December 21, 2023

RE: Additional Information Required and Issuance of Corrective Action, Grassy Valley Groundwater and Surface Water Monitoring Report September 2023; Permit No. M-1980-244

Attachment 1

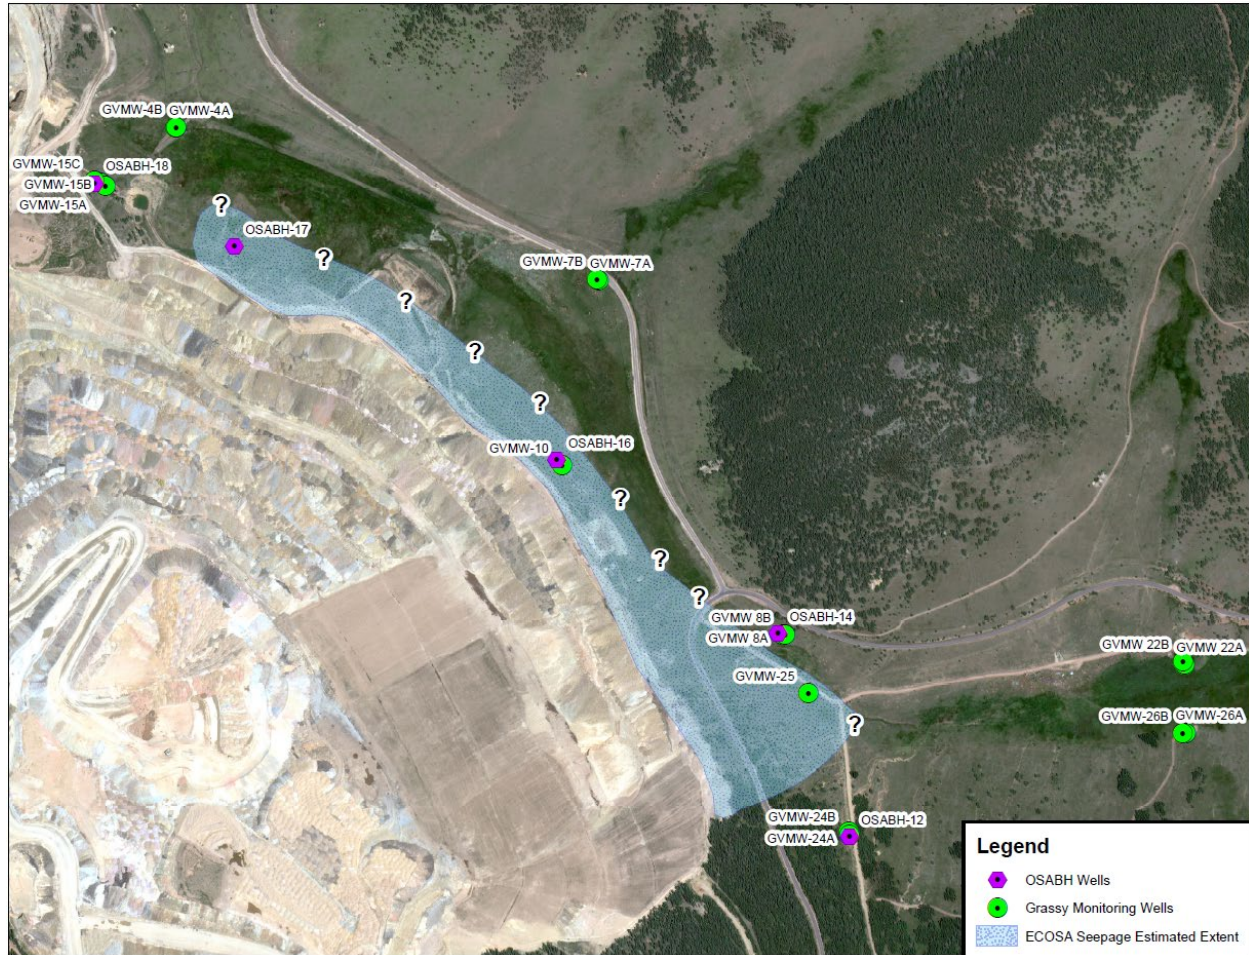
1. *The Division believes the extent of seepage from the ECOSA has been poorly defined to date. The Operator will provide to the Division their estimate of the aerial extent of seepage from the ECOSA and a narrative for describing the reasoning for that extent. The due date for this item is December 22, 2023.*

Based on water quality data, CC&V hypothesizes that potential seepage of mine impacted water from ECOSA has been observed at groundwater monitoring wells GVMW-25 & OSABH-17 on the ECOSA (southwest) side of the thalweg of Grassy Valley. It is uncertain whether or how far beyond these wells the seepage may extend, but there is no indication of seepage observed on the opposite (northeast) side of the thalweg as seen from water quality data at monitoring

wells GVMW-7A/B, GVMW-8A/B, & GVMW-22A/B based on the groundwater quality results. Likewise, monitoring wells OSABH-18, GVMW-4, and GVMW-15 at the north western end of Grassy Valley are typically dry and do not contain groundwater influenced by ECOSA seepage. There has also been no indication of seepage at the new Point of Compliance Wells GVMW-26A and GVMW-26B. A map of the estimated areal extent is provided in Attachment 1.

- Question marks (?) indicate uncertainty with whether or how far beyond the potentially impacted wells seepage may extend
